Working Party on Noise and Tyres

UN Regulation No. 9 (Noise of three-wheeled vehicles)**Proposal for amendments to the 08 series of amendments to
UN Regulation No. 9****Submitted by the experts from the International Motorcycle
Manufacturers Association***

The text reproduced below was prepared by the expert from the International Motorcycle Manufacturers Association (IMMA), in order to align the 08 series of amendments to UN Regulation No. 9 with standard 10844:2014 of the International Organization of Standardization (ISO). It is based upon UN Regulation No. 9 up to Supplement 1. The modifications to the Regulation are marked in bold for new or strikethrough for deleted characters.

“Figure 1
Test track layout with dimensions in meters

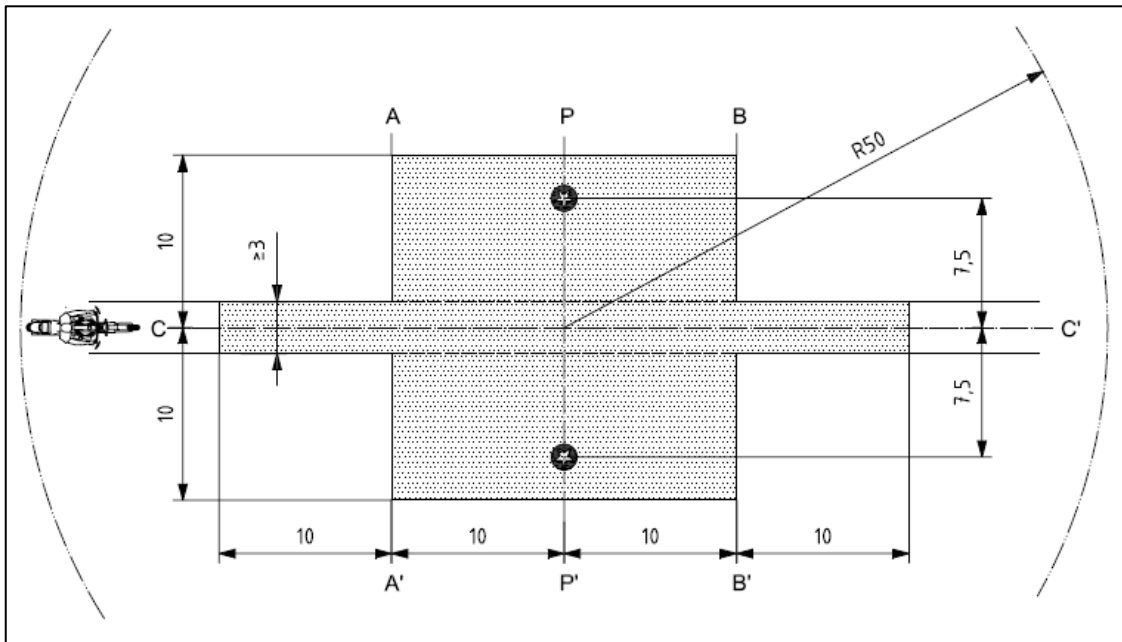
Figure 1, amend to read:

2. IMMA would like to replace the current Figure 1 of Annex 5 with the one above in higher resolution. Such figure derives from an older version of standard ISO 10844; it was then modified to include a picture of a motorcycle that was not in ISO 10844. ISO has confirmed permission to use such figure.

Minimum area covered with test road surface, i.e. test area
	Microphone positions (height 1,2m)

Source: ISO 10844:1994, with modifications.”
